MAGICOM MAIN LOGIC SCHEMATIC REVISIONS

| MATERIAL: | DRAWN BY | DATE | DWG TITLE MAGICOM MAIN LOGIC | DWG NO. | | REV G SHEET 1 OF 1 | |

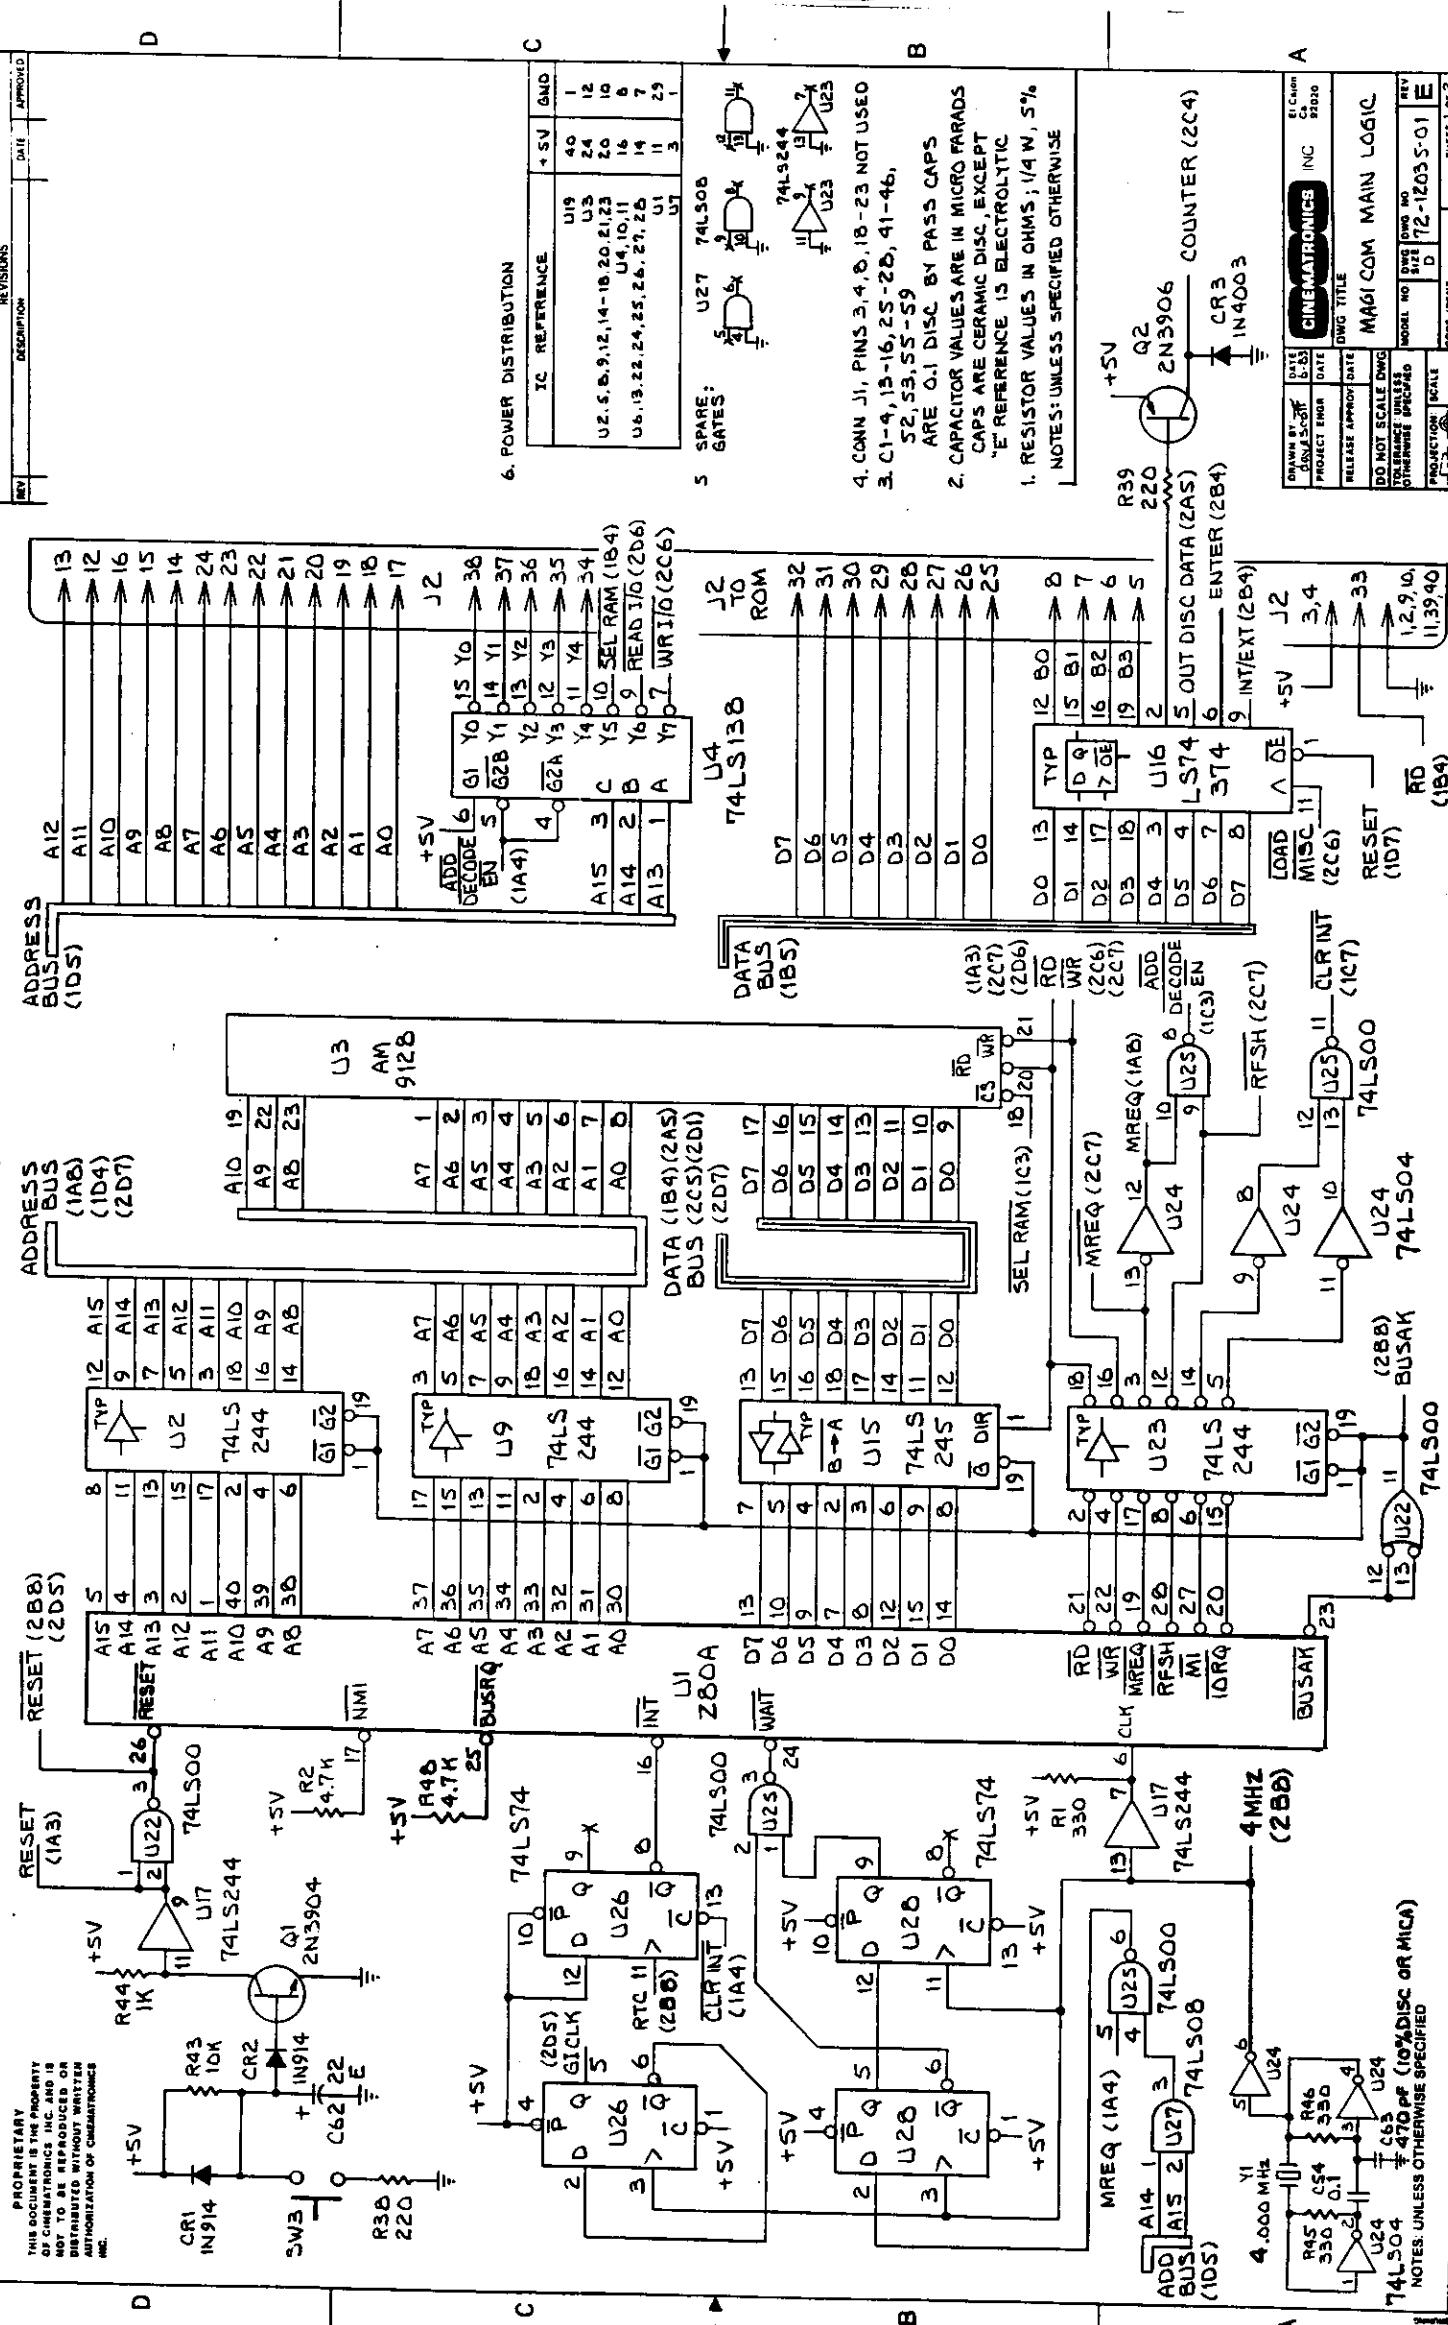
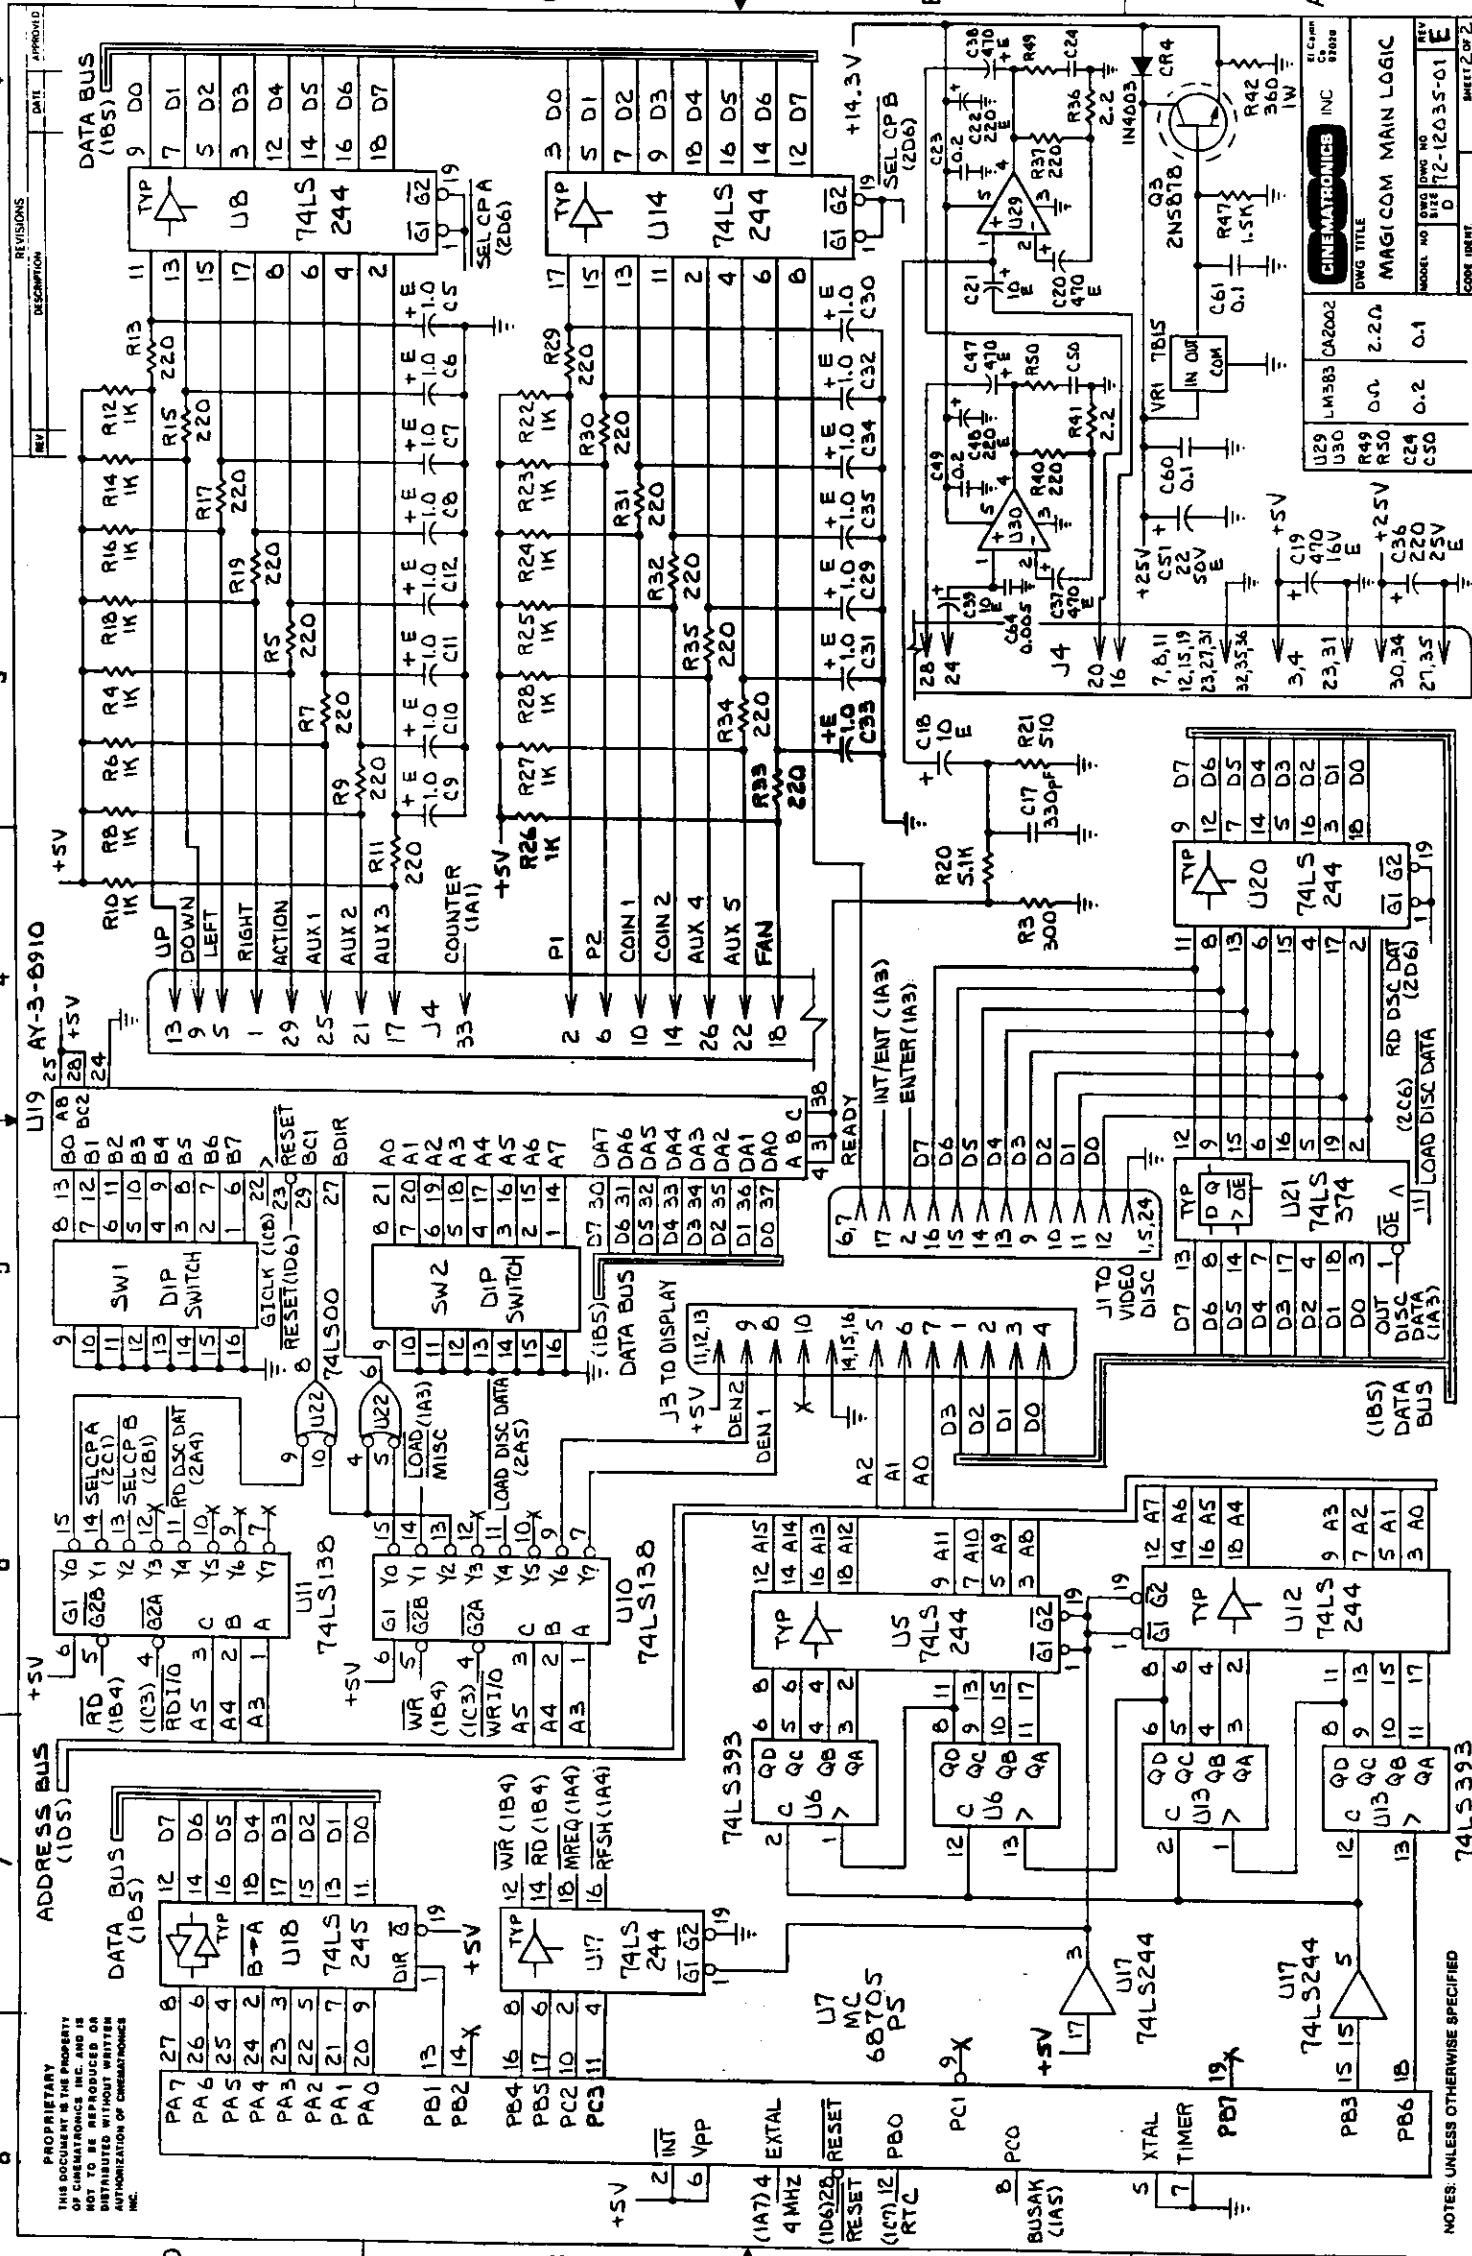
- A. Original release.
- B. R3: Was 1K; became 300.
D0 on U20 incorrectly shown as Pin 8. Changed to pin 18 on 6/23/83.
- C. Addition of capacitor C63, 220pf disc between U24, Pin 3 and ground. 6/27/83.

- D. C54: Was 0.001uf disc. Became 0.1uf disc on 6/29/83.
C63: Was 220pf disc. Became 0.001uf disc on 6/29/83.
74LS244 inserted between 4MHz signal and U1 (Z80), Pin 6. U17, Pins 13 and 7 used - these were formerly a spare gate. 6/29/83.

- E. C40, 0.01 disc tied between U22, Pin 2 and ground is deleted.
74LS244 inserted between Q1 collector and U22, Pins 1 and 2. U17, Pins 11 and 9 used - these were formerly a spare gate.
U1(Z80), Pin 25 cut from U7 (MC68705P5), Pin 9. U1(Z80), Pin 25 tied to R48 (new addition) 4.7K $\frac{1}{4}$ W 5% resistor. Other side of R48 tied to +5V.
U18(74LS245), Pin 19 cut from U7(68705), Pin 14. U18, Pin 19 tied to +5V.
U17(74LS244), Pin 17 cut from U7, Pin 19. U17, Pin 17 tied to +5V.
U23(74LS244), Pin 1 cut from U22(74LS00), Pin 11. U23, Pin 1 tied to ground.
All of "E" above were effective on 7/8/83.

- F. Deletion of the following effective 7/8/83:
 - U5 74LS244
 - U6 74LS393
 - U12 74LS244
 - U13 74LS393
 - U17 74LS244
 - U18 74LS245Substitute U23 for U17 (74LS244) for clock signal into Z80 (U1, Pin 6 from U23, Pin 7) and reset signal into U22, Pins 1 and 2 from U23, Pin 9 effective 7/8/83.

- G. C63: Was 0.001uf disc. Became 470pf effective 9/5/83.
- H. Reset signal sent from U23, Pin 9 to U16, Pin 1 to cure false coin count on power up.
- I. Reference letter not used.

J. Correct pin out for inputs on U20(74LS244) effective 9/16/83.

K. C63: Was 470pf disc; became 330pf disc.

C17: Was 330pf mica; became 330pf disc.

Addition of U31(74LS74) to divide clock.

Y1: Was 4.000MHz; became 16.000MHz.

U24: Was 74LS04; became 74S04.

Addition of R29 between U29, Pin 4 and C24.

Addition of R50 between U30, Pin 4 and C50.

These two additions allow option for U29 and 30 with the following components:

Addition of Jumper W1, when installed, allows board to be used with Pioneer 7820 disc player with proper software.

Deleted: U7 MC68705

Addition (reinstallation) U6, 74LS393

U13, 74LS393

U6, Pins 2 and 12, and U13, Pins 2 and 12 all grounds.

U6, Pin 6 tied to U26, Pin 11 (RTC).

U13, Pin 13 tied to U26, Pin 5 (GI CLK)

All of "K" above effective 10/10/83.

"K" revision schematic is for "C" revision printed circuit board used with LDV-1000 laser disc player.
